GENE-770-06-1-A

BASES FOR CHANGES TO SURVEILLANCE TEST INTERVALS
AND ALLOWED OUT-OF-SERVICE TIMES FOR SELECTED
INSTRUMENTATION TECHNICAL SPECIFICATIONS

UNITED STATES
NUCLEAR REGULATORY COMMISSION
WASHINGTON, D.C. 20555

SUBJECT: GENERAL ELECTRIC COMPANY (GE) TOPICAL REPORT GENE-770-06-1,
"BASES FOR CHANGES TO SURVEILLANCE TEST INTERVALS AND ALLOWED
OUT-OF-SERVICE TIMES FOR SELECTED INSTRUMENTATION TECHNICAL
SPECIFICATIONS"

Figure 1
LDW-LDW SET FAULT TREE FOR HATCH 2

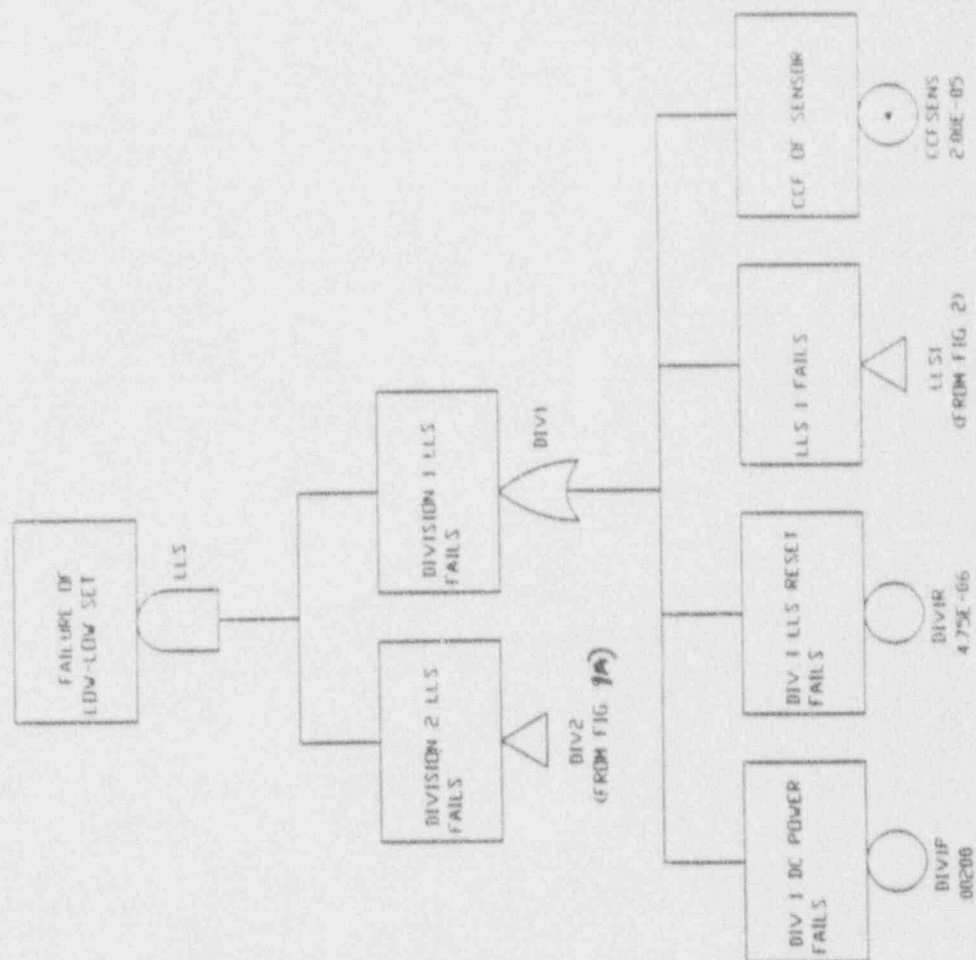
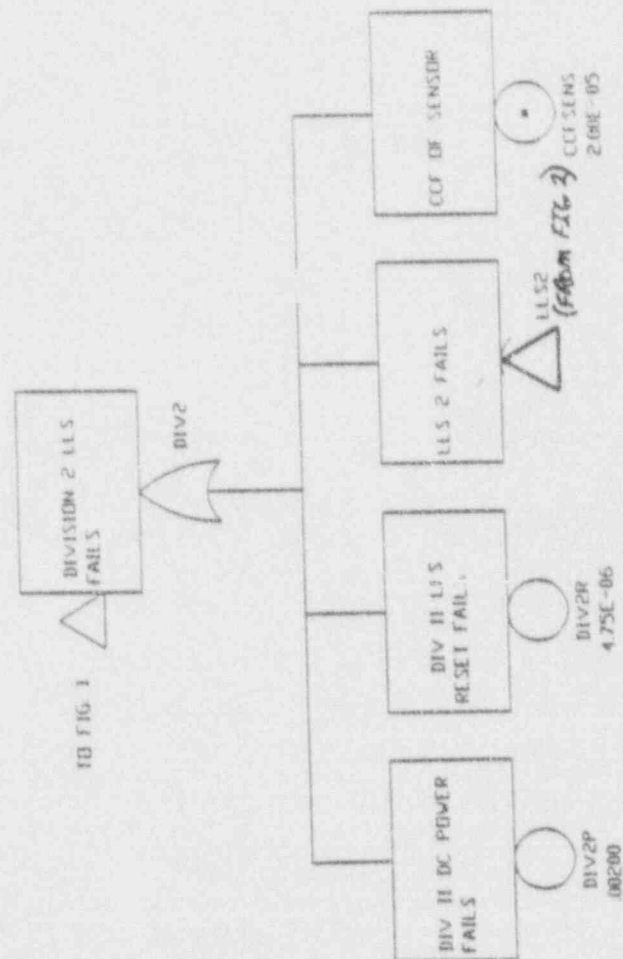
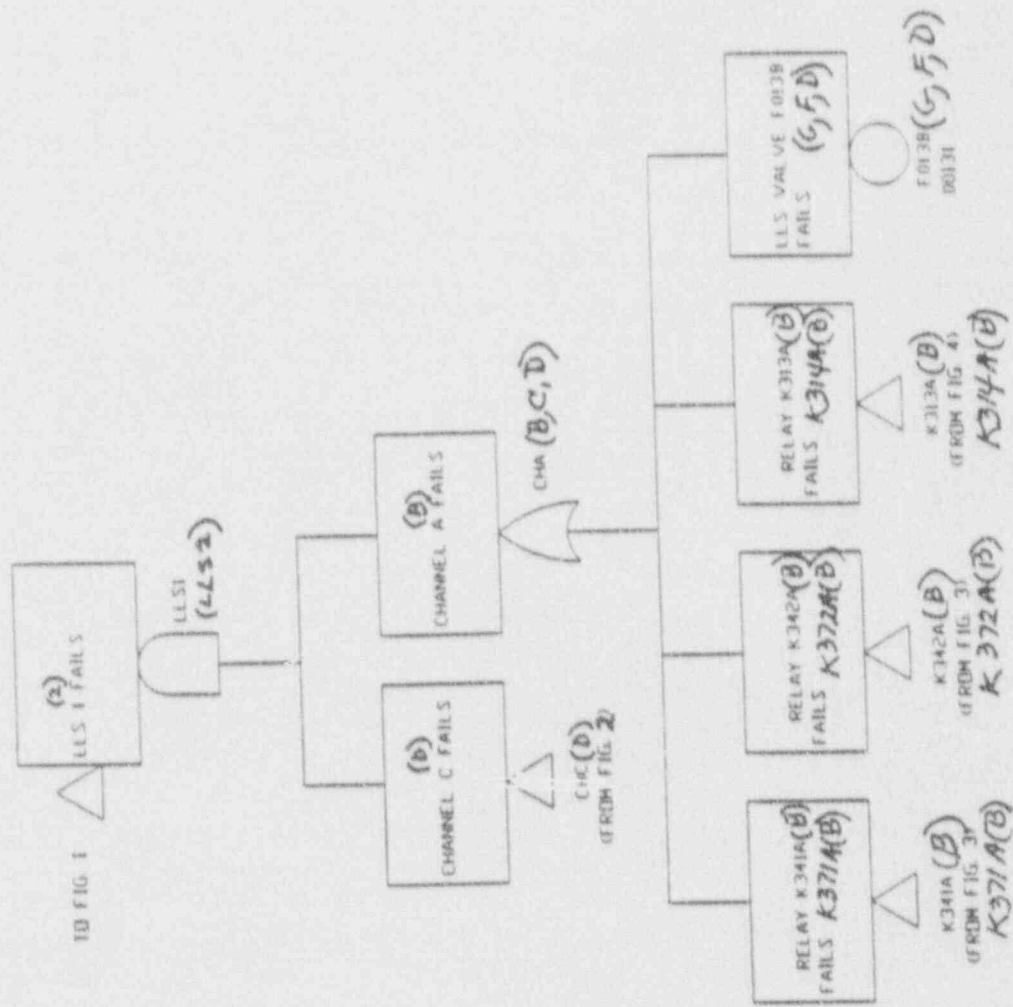
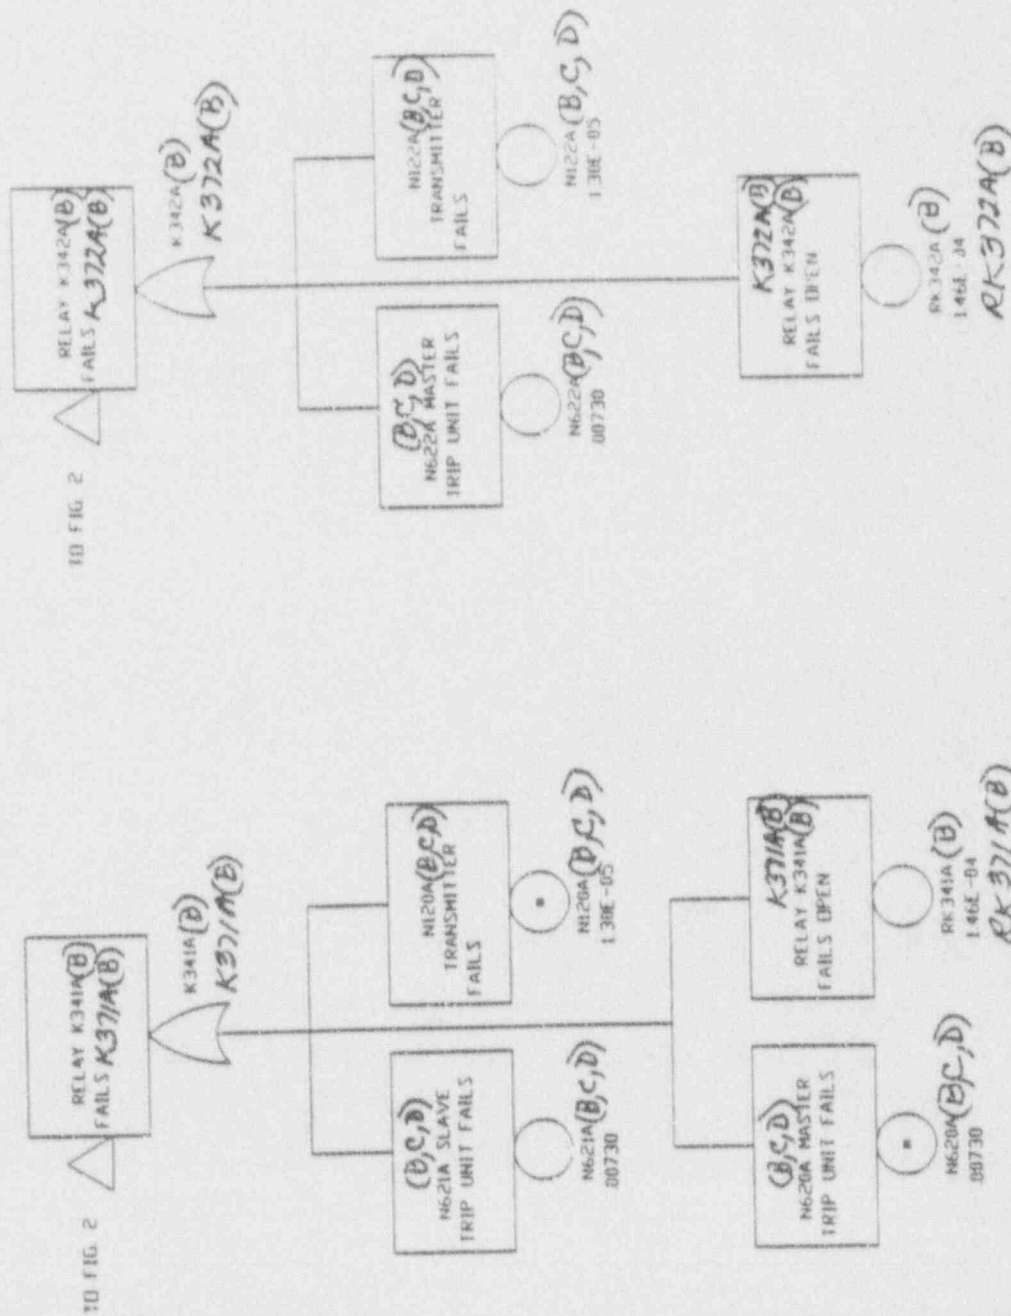
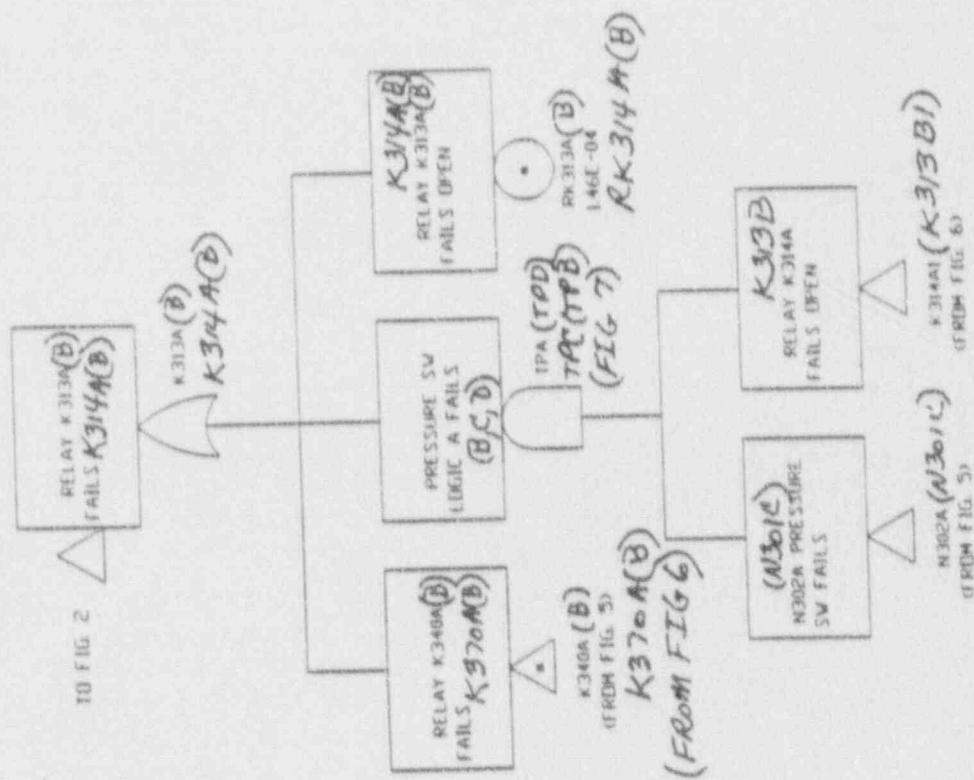
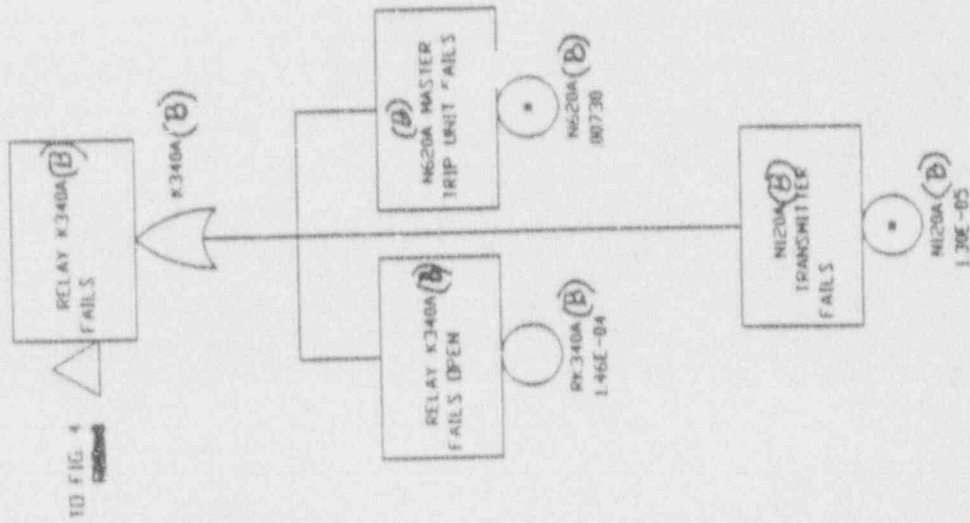
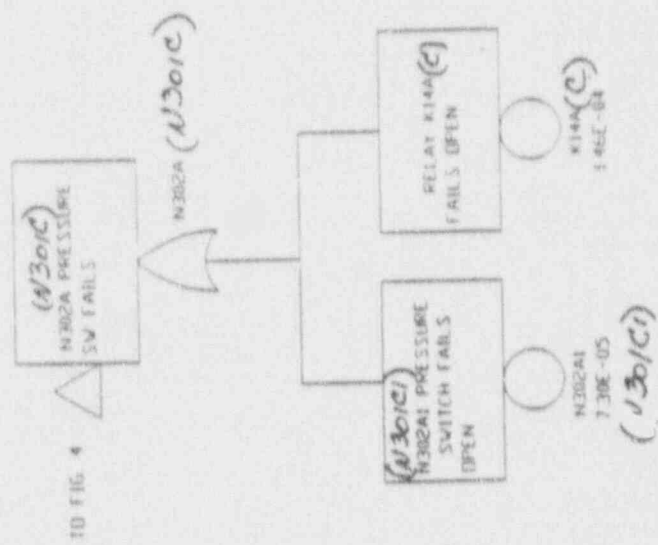
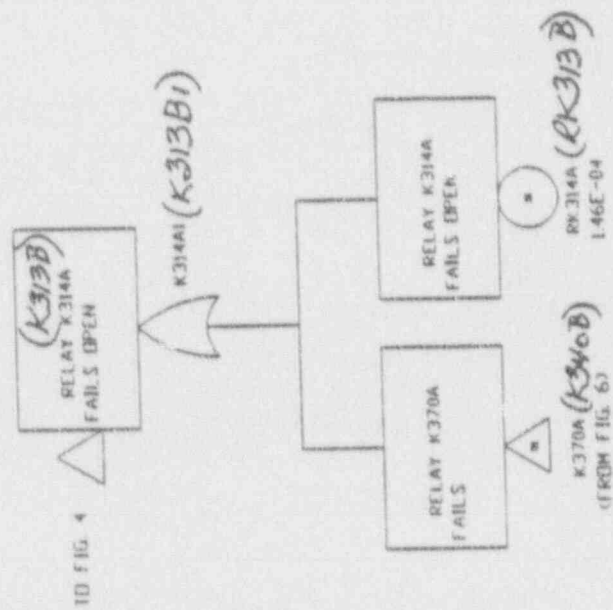
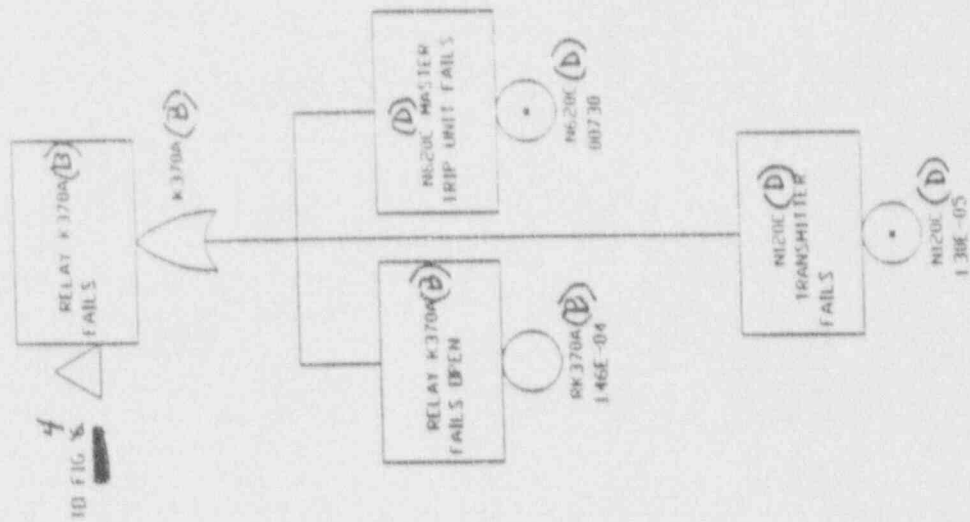
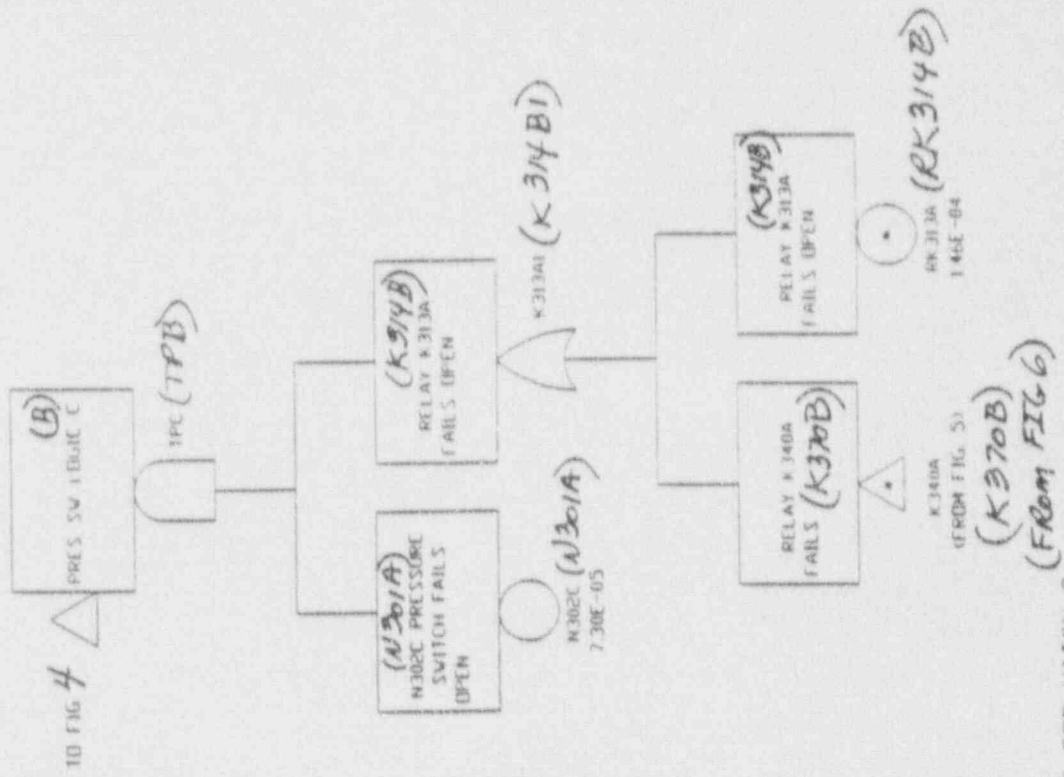
In response to our Question Four, the BWROG submitted additional information consisting of fault trees and evaluations for the BWR4 LLS logic. In our review of this information, we agree that four of the eleven S/RVs can be actuated by the LLS logic and that only one of the four needs to open to fulfill the LLS function. We did, however, question whether the channel logic used for the fault trees followed the channel logic as presented, for example, in the Hatch, Unit 2, BWR4 plant. Our review showed two LLS logic channels in each Division: Channels A&C for Division I and channels B&D for Division II with each channel actuating one of the four LLS valves as follows. A permissive relay receives a signal on reactor vessel high pressure from PT1(x)[N120(x)]. These relays are assigned as follows: Channel A-K340A, Channel C-K370A, Channel B-K340B and Channel D-K370B. The contacts of each such permissive relay are wired in series with the coil of the arming relay and the paralleled contacts of the tail pipe switches associated with that channel. The arming relays are: Channel A-K313A, Channel C-K314A, Channel B-K313B and Channel D-K314B. Actuation of an arming relay seals it in through a set of auxiliary contacts. Each of the 11 S/RV tailpipes is equipped with two pressure switches which senses actuation of the S/RV. One of these switches

For the BWR4 LLS function, it is stated that failure of the LLS function to initiate will not have an immediate adverse effect on the plant safety and therefore, that any small change in actuation instrumentation unavailability due to changes in the STI and AOTs may be neglected. However, the changes in the SRV LLS function actuation instrumentation unavailability caused by changes in the STI and AOTs have not been shown to be small enough to neglect. The argument is made that the reasoning which supports making the requested changes is bounded by the analyses performed for the ECCS and isolation actuation instrumentation and further that the analyses apply because the components used in the systems are the same or similar and the number of failures needed to disable the system are comparable. This argument as presented is unacceptable because it appears to fail to consider the manner in which those components are assembled into the LLS logic. For example, the LLS logic is an armed logic which is not similar to any of the ECCS or isolation actuation logic. Some of the subsystems may be similar but the manner in which they are organized into the logic is different, therefore the fault trees and their evaluation may differ and the results may not be bounded by the previous analyses. This has not been shown and neither has it been shown that the number and type of failures needed to disable the LLS actuation instrumentation is comparable to that for an identified previously reviewed ECCS or isolation actuation system. The topical report should be revised to demonstrate the similarity of this logic system to a specific reference logic system or systems.

Enclosure 4 provides a fault tree of the low-low set (LLS) for the Hatch 2 plant. There are 11 safety/relief valves (S/RVs) at the Hatch 2 plant. Four of these are actuated by the LLS. Failure of the LLS function requires failure of all 4 LLS valves. Each LLS valve is armed by a relay in a logic channel initiated by a high reactor pressure trip unit and one of the S/RV tail pipe pressure switches. Two of the valve arming logic channels receive trip signals from 5 tail pipe pressure switches. The remaining two arming logic channels receive trip signals from 6 tail pipe pressure switches. Each of the 11 S/RV tail pipes

A calculation of the LLS unavailability as a function of surveillance interval is given in Enclosure 4. Two LLS valves were assumed to open. The change in LLS unavailability when the surveillance interval is extended from 1 to 3 months is $3.92E-05$ /demand. This change is acceptably low based on the function and failure consequences of the LLS (i.e., reduce the number of load cycles on the containment and S/RV discharge lines and reduce the number of S/RV actuations during the plant lifetime).

BWR 4 MCRECS INSTRUMENTATION

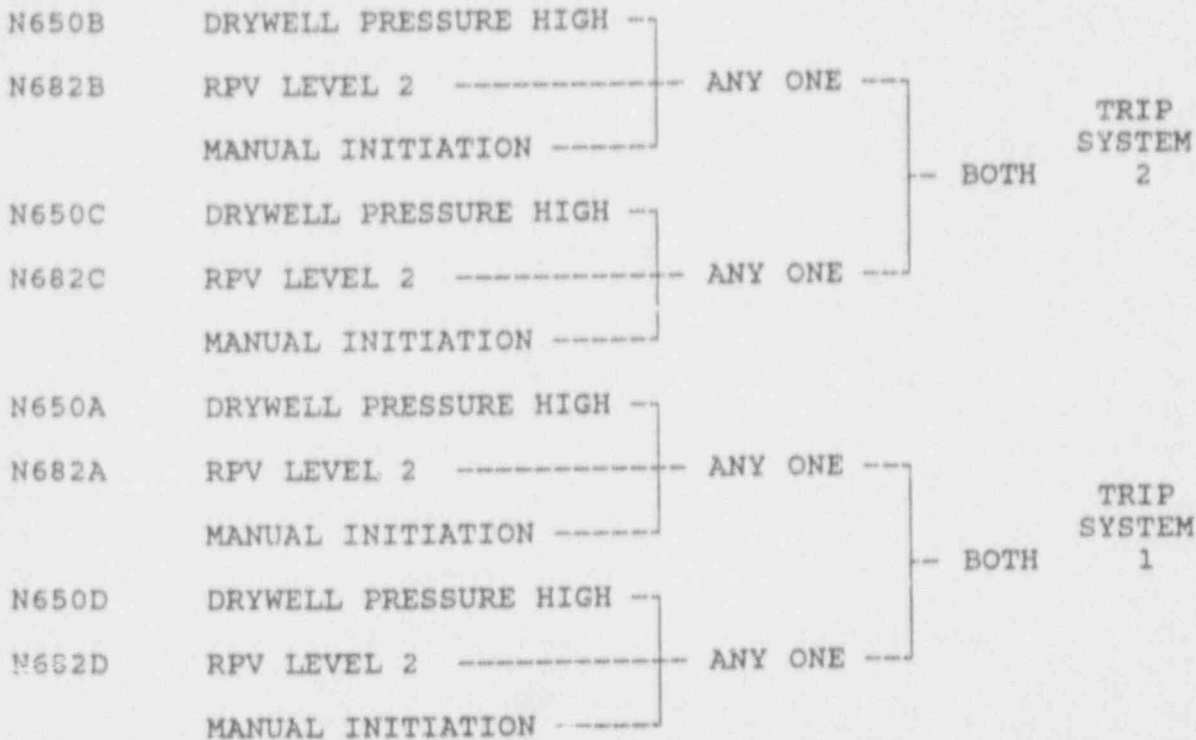
The reference given for the reactor vessel water level 1, high drywell pressure, and main steam line high flow inputs to the MCRECS was not acceptable because it did not appear to provide analyses against which to compare the reactor vessel water level 1 and main steam line high flow inputs. Further, in the basis, such a comparison was not made and initiation of MCRECS was not addressed.

For the BWR4 Main Control Room Environmental Control (MCREC) Actuation Instrumentation, please provide specific references for the reactor vessel water level 1, high drywell pressure, and main steam line high flow inputs to the MCREC systems. The quoted reference did not address the water level 1 and main steam line high flow inputs. More specific references should be provided for the MCREC inputs and the similarities in configuration, components and qualification addressed to allow comparison to be made and conclusions drawn. Also, please provide additional information on how the high control room and the refueling floor area radiation functions are similar to the reactor building exhaust high radiation function to enable judgement to be made as to whether the fault trees and their evaluation are applicable to the high control room and the refueling floor area radiation functions.

The logic that initiates MCREC is similar to the logic given in the case studies for BWR plants. Instead of closing an inboard and outboard valve, the logic initiates redundant MCREC subsystems. The logic therefore is analogous to the logic given under the column headed "Logic Type Per Valve Per Variable". The only exception is the logic for a LOCA signal. The trip units and logic for the LOCA signal is the same signal that actuates the ECCS low pressure systems analyzed in Reference 5. The LOCA signal is also similar to the 1 out of 2 twice logic in Reference 6 except there are 2 variables instead of 4.
